**CUSTOMER SERVICE**  
**SERVICE BULLETIN**

**GT wheel hubs may show excessive wear after extensive use.**

**WORN HUB, BRACKET & WASHER**

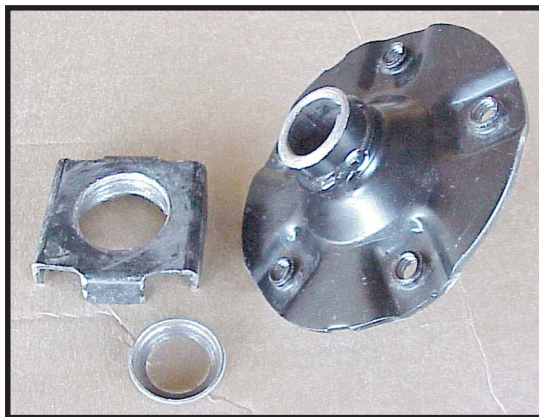
ON SPECIFIC AUTOMATIC TRANSAXLE UNITS, THE KEYWAY INSIDE THE WHEEL HUB MAY BECOME DAMAGED DUE TO AN UNDERSIZED 2" KEY AND SOFT WASHERS. THERE MAY BE WEAR ON THE INSIDE SURFACE OF THE REAR WHEEL HUB, WASHERS AND AXLE FLANGE BRACKETS INBOARD OF THE GT WHEEL HUB. THIS CONDITION MAY DEVELOP AFTER SEVERAL HUNDRED HOURS OF EXTREME USE.

REMOVE THE TWO PLASTIC AXLE CAPS IF EQUIPPED, E-RINGS, AND OUTSIDE WASHERS AT THE END OF THE TRANSAXLE SHAFTS. REMOVE THE REAR WHEEL HUB ASSEMBLY, WASHERS/SPACER, THE 2" KEYS ON BOTH AXLES, AND THE TWO AXLE FLANGE WASHERS ADJACENT TO TRANSAXLE. INSTALL KIT# 180696 IN THE ORDER ILLUSTRATED. INSPECT THE WHEEL HUB FOR ANY CRACKS OR WEAR. IF THE WHEEL HUB IS CRACKED OR SHOWS EXTENSIVE WEAR REPLACE WITH PART # 140507. WHEN INSTALLING THE AXLE FLANGE WASHER, THE WIDER FLANGES GO ON TOP AND BOTTOM OF TRANSAXLE AS ANTI-ROTATIONAL FEATURES. REINSTALL ORIGINAL TWO E-RINGS, OUTSIDE WASHERS AND PLASTIC HUB CAPS.

**NOTE: DO NOT REUSE ORIGINAL 2" LONG KEY, OR ORIGINAL WASHER / SPACER.**
